**CALIFORNIA  
HIGH-SPEED RAIL  
AUTHORITY**

**BRIEFING: APRIL 2010 MEETING AGENDA ITEM #7**

**RE: Transbay Transit Center Design / Trainbox**

**Subject:** **Review of Transbay Transit Center Design of March 9, 2010**

CALTRAIN DOWNTOWN EXTENSION  
 650' RADIUS HSR TRACKS  
 AND PLATFORM EXTENSION STUDY  
 FIGURE 1  
 MARCH 9, 2010

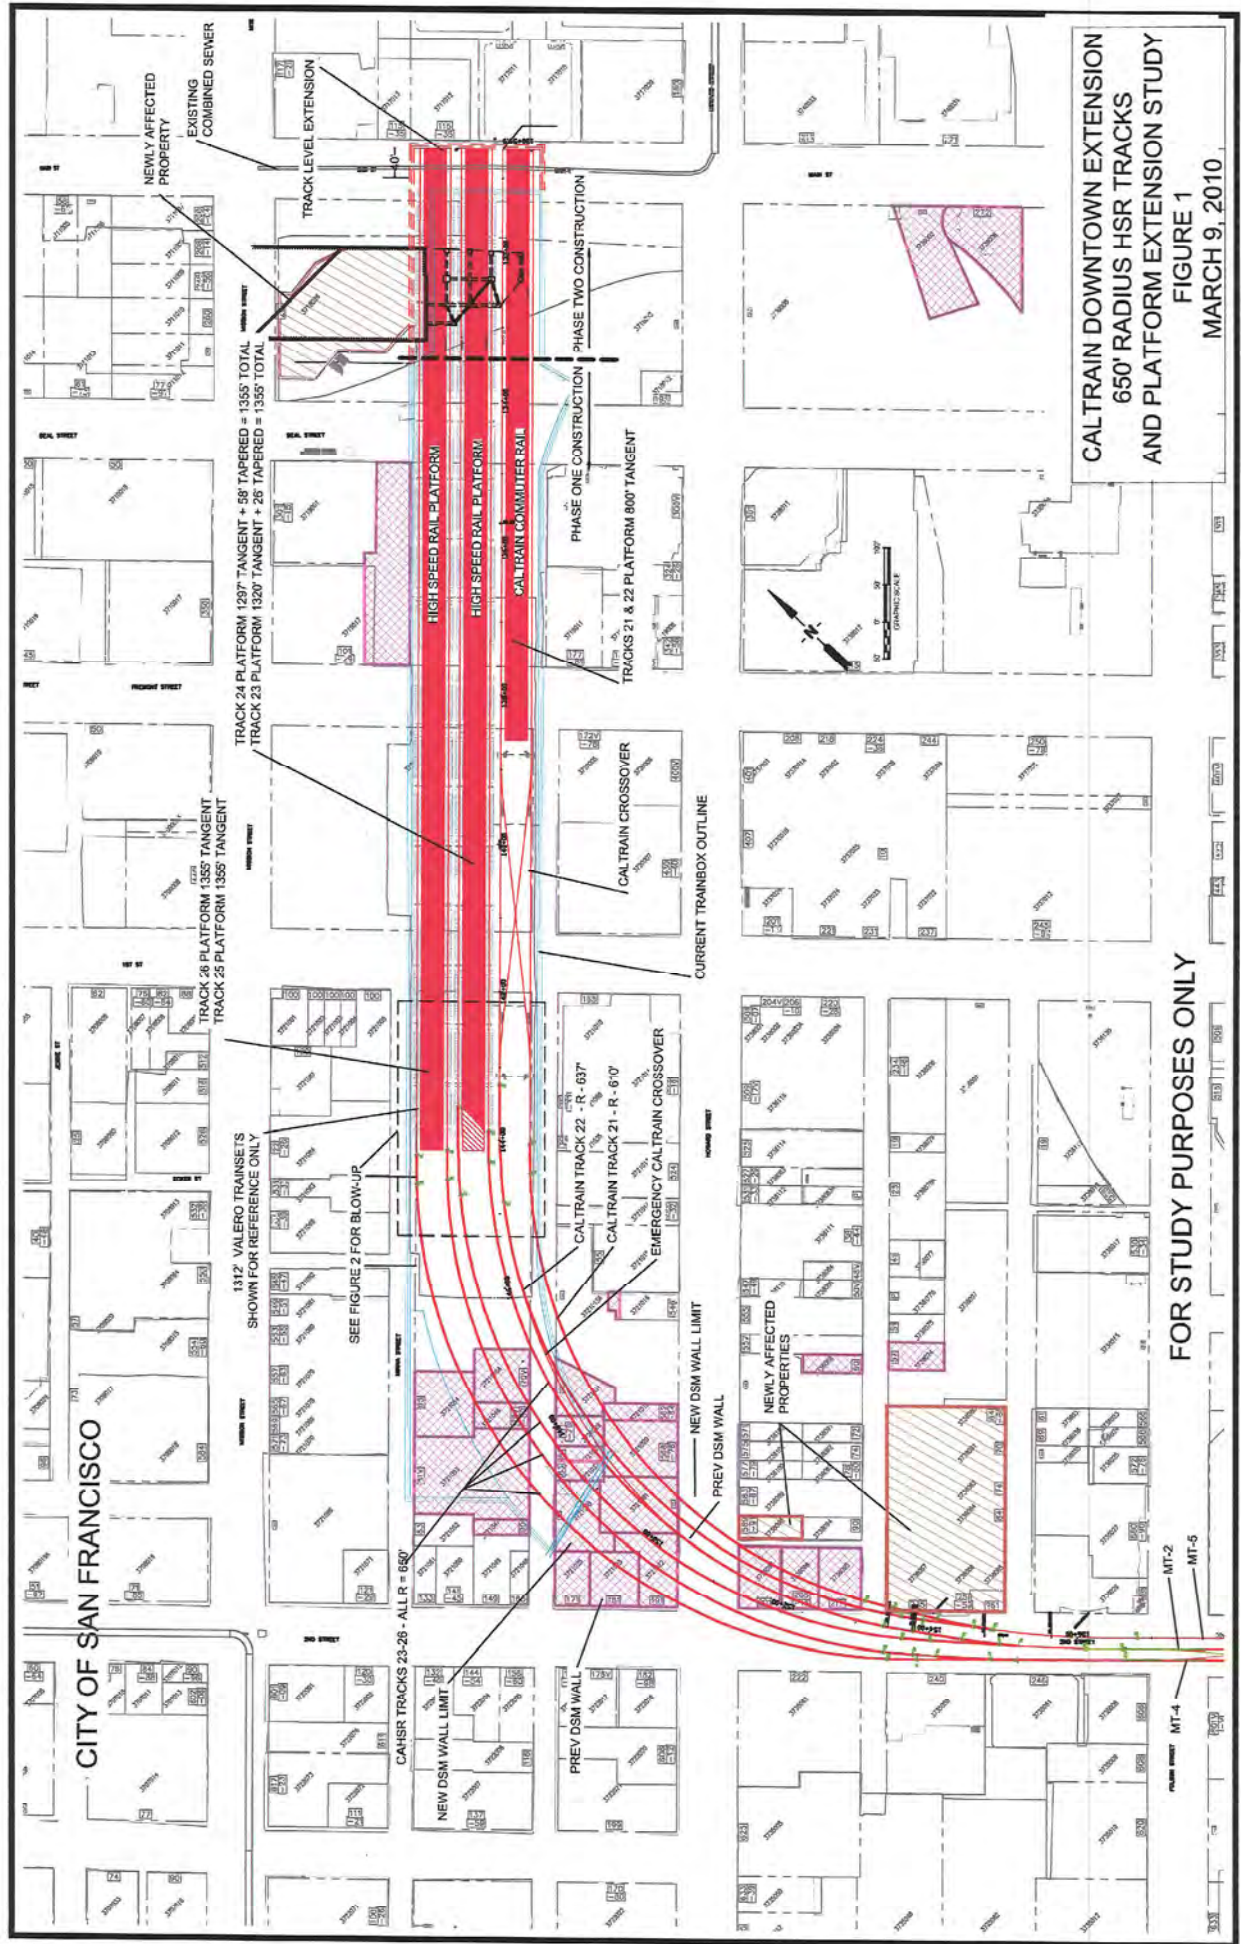
Horizontal radius of 650-foot is commensurate with the tightest radii (622-foot / 190 m) that the EMT has found in revenue service at Cologne Central Station. This will require a design variance for it to be accepted as part of the HST system.

Alignment does not provide length of tangent track (75 foot) either side of platform needed to ensure swing of the cars do not require a tapered platform. In the absence of the tangent, we assessed platform tapers is all that is required. This will also require a design variance.

In the absence of a design, the 40 foot length of track to allows for 30 feet inclusive of physical 'bumper' requirements plus a 10 foot distance from normal train parking position for end stop requirements. This 40 total distance would require a 3-5 mph operational speed.

Platforms (23, 24, 25 or 26) meet the exceptional design criteria length of 1315 feet. The 1315 foot exceptional length does not provide for the TSI (European Technical Specifications for Interoperability) tolerance that permits train length to be increased 1% for aerodynamic design. A design variance will be required for the total length of the platforms.

Platforms on tracks 23, 24, 25 and 26 will all require additional offsets due to the adjacent or proximate curves in the platform tracks. The beginning point of the need for additional car to platform clearance is based on the point at which the swing in the car body begins due to curvature, which is based on vehicle characteristics.

Track 23: 82.5 feet into the platform, maximum offset at end: 10.1 total inches or a 7.1 inch additional gap.

Track 24: 108.9 feet into the platform, maximum offset at end: 6.7 inches or a 3.7 inch additional gap.

Track 25: 56.5 feet into the platform, maximum offset at end: 4.7 inches or a 1.7 inch additional gap.

Track 26: 29.1 feet into the platform, maximum offset at end: 3.7 inches or a 0.7 inch additional gap.

A design variance would be required for the potential platform gap issues.

CAL TRAIN DOWNTOWN EXTENSION  
 650' RADIUS HSR TRACKS  
 AND PLATFORM EXTENSION STUDY  
 16 March 2010  
 \* Based on Shinkansen N700

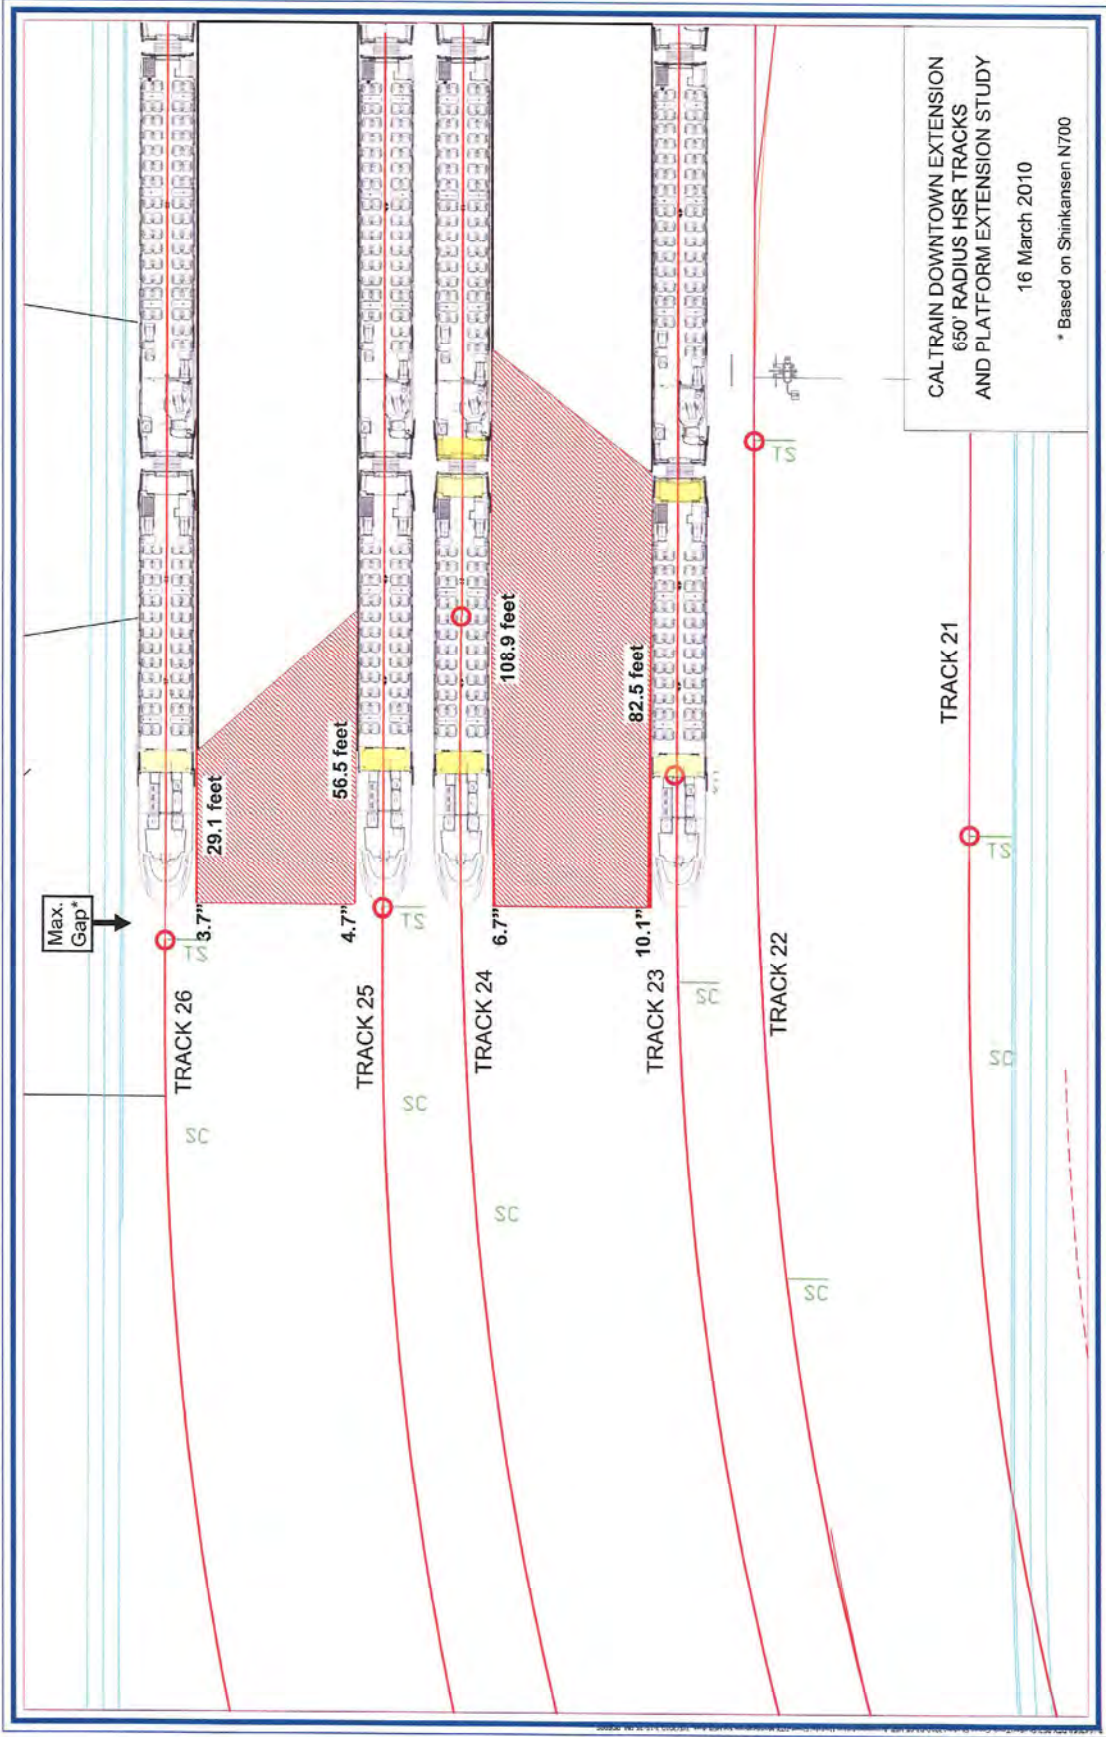
For the Shinkansen equipment, as a typical case, with the ADA standard offset of 3 inches:
